Product Change Notification

Change Notification #: 117115 - 00

Change Title: Intel® Server System R2312WFTZSR,
PCN 117115-00, Product Design,
3.5" Tool-Less Carrier Design Improvement for
2.5" Drive Support

Date of Publication: August 12, 2019

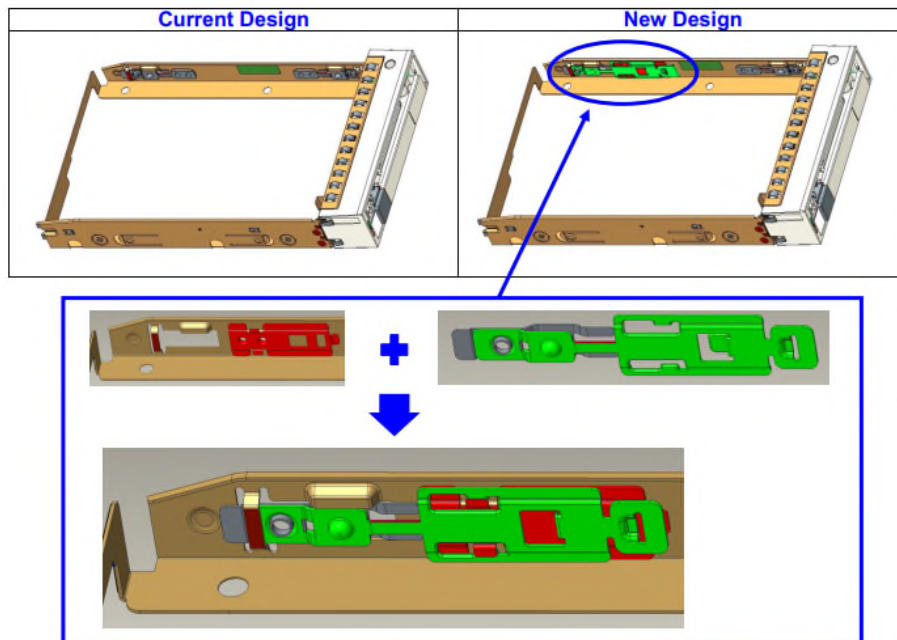
Intel is implementing an improvement on the Intel® Server System R2312WFTZSR for the 3.5" tool-less drive carrier when used for 2.5" drive support, from a non-removable to a new removable rear spring (see image in green) and new spring holder (see image in red) attached to the tool-less drive carrier.

Removing the new rear spring of 3.5" tool-less carrier when installing 2.5" SSD drive, installing the rear spring to support 3.5" HDD.
